INSPECTION AND REPLACEMENT OF NOSE GEAR DRAG LINKS

Lancair IV, IV-P, IV-PT, and Legacy

SB078-0722

Figure 4

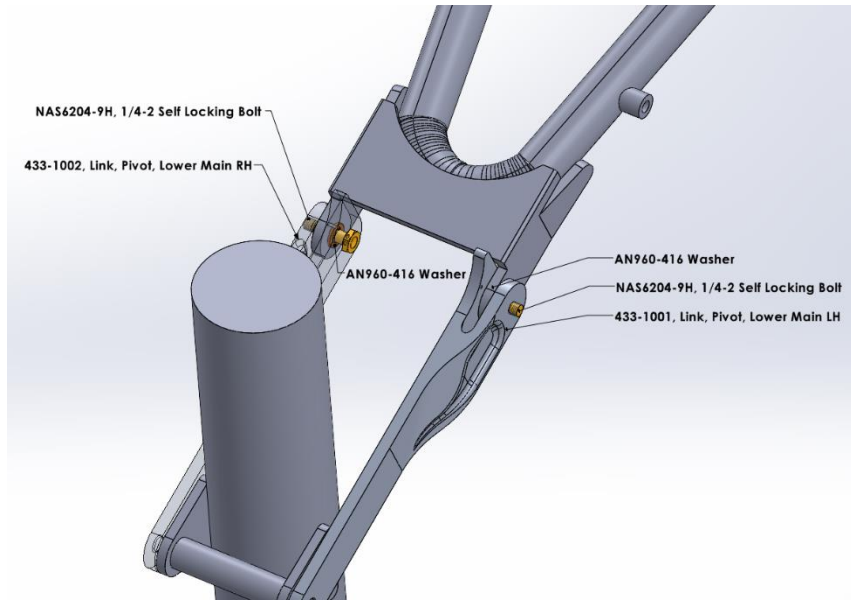
- 7.2** Procedure (See Figure 2 and 4):
- 7.2.1** Lubricate lightly and install the new 433-1001 Lower Drag Link LH and 433-1002 Lower Drag Link RH.
- 7.2.2** Install the new lower links to the over center link using NEW NAS6204-9H Self Locking Bolts (head on inside of the assembly, threads going outboard) and AN960-416 Washers.

- 7.2.3** Before attaching the 433-1001 & 433-1002 Lower Drag Links to the nose strut, torque the above bolts to 90-100 in./lb. and ensure each of the two lower links will pivot on the upper link through the full range of movement required during gear retraction.

If the full range of motion is achieved, safety wire both NAS6201-9H Self Locking Bolts to the corresponding Lower Drag Link. A small hole for safety wire can be found on the curvature of the stop.

Figure 5

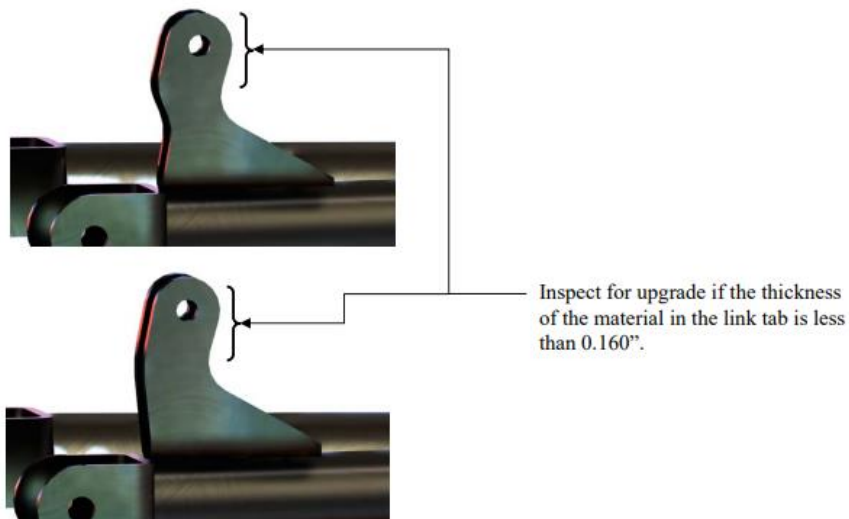
NOTE: The Upper Over center Link Assembly has been upgraded to a stronger part by SB074-0111. If you have not complied with this service bulletin, it is recommended that SB074-0111 be incorporated at this time.

SB074-0111 applies to both over center link tab configurations shown in Fig. 4, SB074-0111 also addresses the installation of a Hydraulic actuator end with a spherical bearing. For further details on the inspection please refer to SB074-0111.
